Official Transcript of Proceedings
NUCLEAR REGULATORY COMMISSION

Title: Advisory Committee on Reactor Safeguards
 Westinghouse AP1000 DCD Subcommittee
 Open Session

Date: Tuesday, November 2, 2010

Impact of Gas Intrusion on IRWST Makeup Water Injection in the AP1000

IRWST Injection Path - Void Present

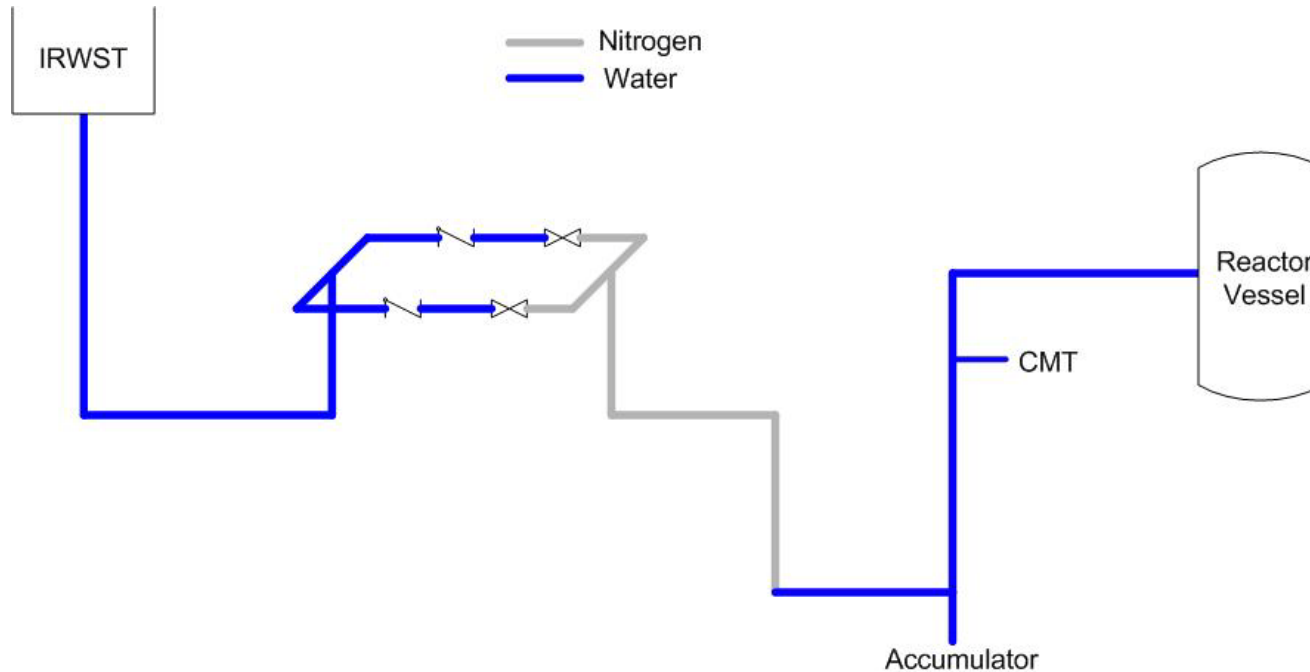
- Current Safety Analysis NOTRUMP Small Break LOCA Evaluation Model (EM) does not explicitly consider gas intrusion
 - Potential delay in onset of IRWST injection
- During February meeting preliminary NOTRUMP simulations were discussed
 - IRWST injection delayed to simulate non-condensable gas accumulation
 - Impact is most significant for smaller breaks and no-break simulations (Inadvertent ADS, INADS)
 - Break in RCS assists in depressurization characteristics
 - 2 inch cold leg break and INADS examined
 - Core uncover predicted
- Peak Cladding Temperature (PCT) response requested
 - SBLOCTA code utilized

[NOTE: (IRWST Valve Elevation – IRWST Injection Tee Elevation) * Density of IRWST Fluid ≈3.4 psi]
